APPLICATION FOR PERMISSION UNDER SECTION 16 OF

申請地點位於新界元朗流浮山丈量約份第129約地段第2098號、第2099號、第2100號(部分)、第2101號A分段(部分)、第2101號B分段(部分)及第2116號(部分),面積約 3005 平方米,由Wecater Group Limited 提出申請,作擬議臨時食肆(為期3年)。(可參閱:場地大綱圖及場地位置圖)

寄件日期:2025年11月14日星期五 11:08收件者:Tracy Wing Sum LAW/PLAND主旨:A/YL-LFS/575進一步資料

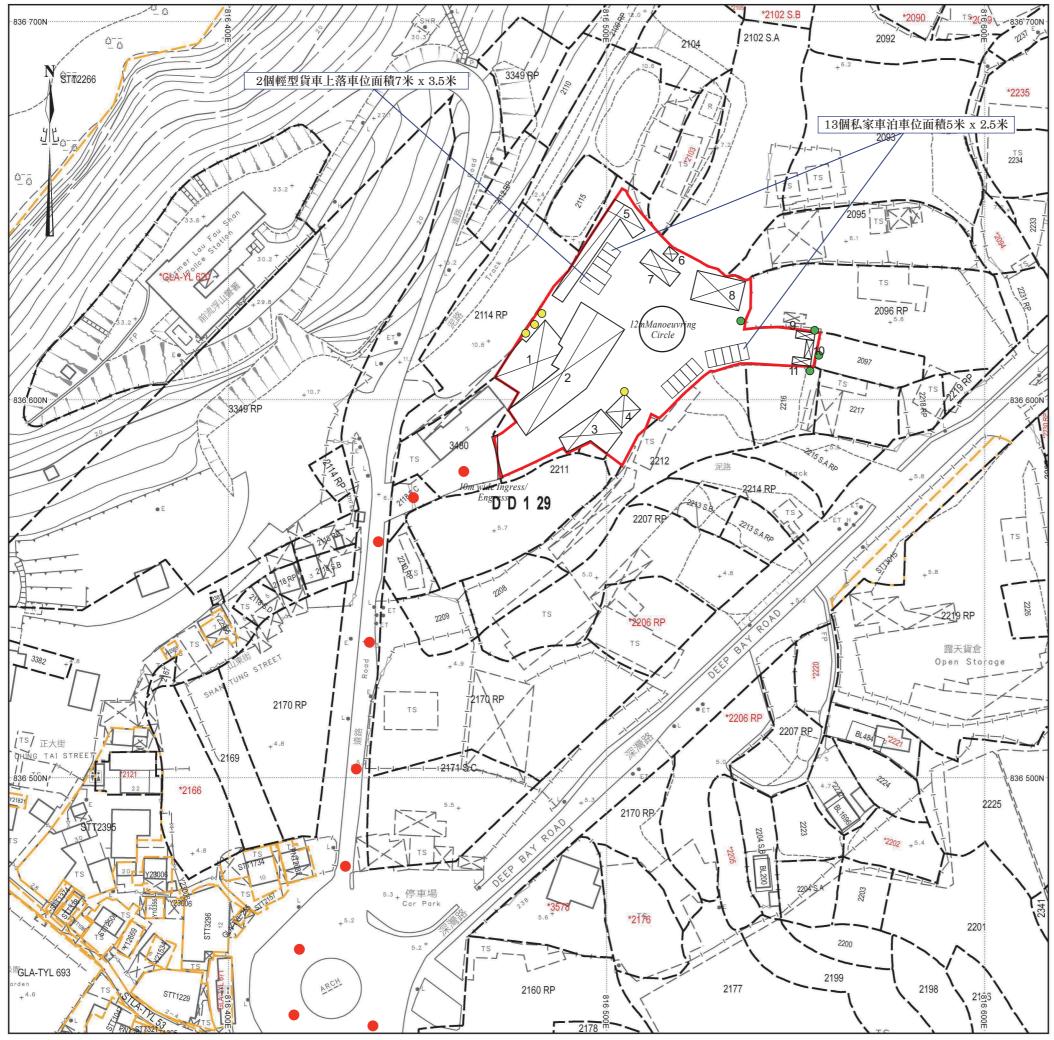
環保署

污水處理方面,洗手間不是臨時式廁所,不會有便槽。而是場內設有化糞池以處理污水,申請人會定期 找專人於場地進行真空吸缸。
